# Access Compliance Report

## Public Rights-of-Way

### (Curb Ramps)

Intersection ID: 53506	Main Street: ALVARADO_WY	Cross Street: ALLISON_LN	Location: NW
ADA ID: 07317298E52E	Ramp Type: PerpDiag	Initial Pass/Fail: Fail	Overall Compliance: No
Severity Score: 33.75			
Codes/Mitigation Info/Possible Solution		Field Measurements/Component Compliance

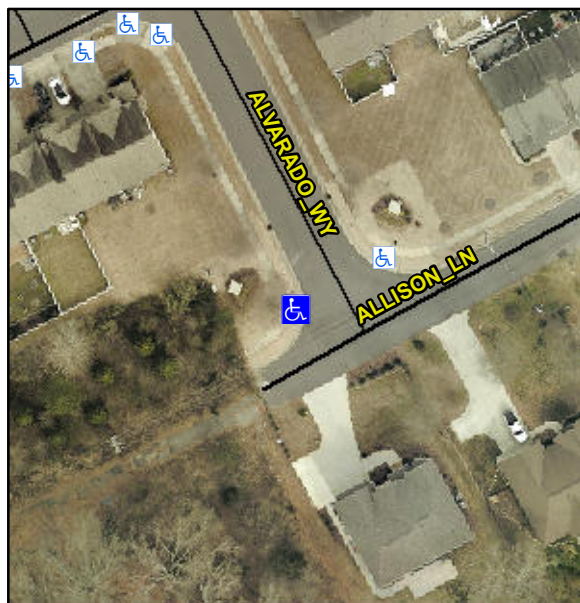
**Not Found, R304.5.1, R304.2.2, R304.5.3**

Compliance	Description	Data	Compliance	Description	Data
N/A	Ramp Length (in)	76.0	No	Ramp Slope (%)	9.0
No	Ramp Width (in)	46.0	No	Ramp XSlope (%)	5.6
N/A	Flare Type LT	N/A	N/A	Flare Type RT	N/A
N/A	Flare Slope LT (%)	N/A	N/A	Flare Slope RT (%)	N/A
N/A	Flare Traversable LT?	N/A	N/A	Flare Traversable RT?	N/A
N/A	Landing Length (in)	N/A	N/A	DWS Provided?	N/A
N/A	Landing Width (in)	N/A	N/A	DWS Contrast?	N/A
N/A	Landing Slope (%)	N/A	N/A	DWS Length (in)	N/A
N/A	Landing X Slope (%)	N/A	N/A	DWS Full Width?	N/A
N/A	Landing Curb? (Y/N)	N/A	N/A	DWS Offset (in)	N/A
N/A	Shared Landing?	N/A			
N/A	Gutter Ponding?	N/A	N/A	Gutter Slope (%)	N/A
N/A	Gutter Lip Ht (in)	1.0	N/A	Gutter X Slope (%)	N/A
N/A	Painted X Walk1?	No	N/A	Painted X Walk2?	No
	X Walk 1 Direction	To SE		X Walk 2 Direction	To NE
N/A	X Walk 1 Width (in)	N/A	N/A	X Walk 2 Width (in)	N/A
	X Walk 1 Slope (%)	0.1		X Walk 2 Slope (%)	4.0
	X Walk 1 X Slope (%)	3.9		X Walk 2 X Slope (%)	1.5

N/A	Ramp inside XWalk1?	N/A	N/A	Ramp inside XWalk2?	N/A
	Road Slope (%)	2.7	N/A	Clear Space?	N/A
	Road X Slope (%)	5.2	N/A	Clear Space to XWalk (in)	N/A
N/A	Any Obstructions?	N/A	N/A	Storm Grate/Utility Hazard?	N/A
	Obstruction Type			Storm Grate/Utility Type	
		N/A			N/A
			Yes	Surface Condition? (G/P)	Good

**Remove & Replace Curb Ramp With Two New Directional Ramps or Equivalent.**
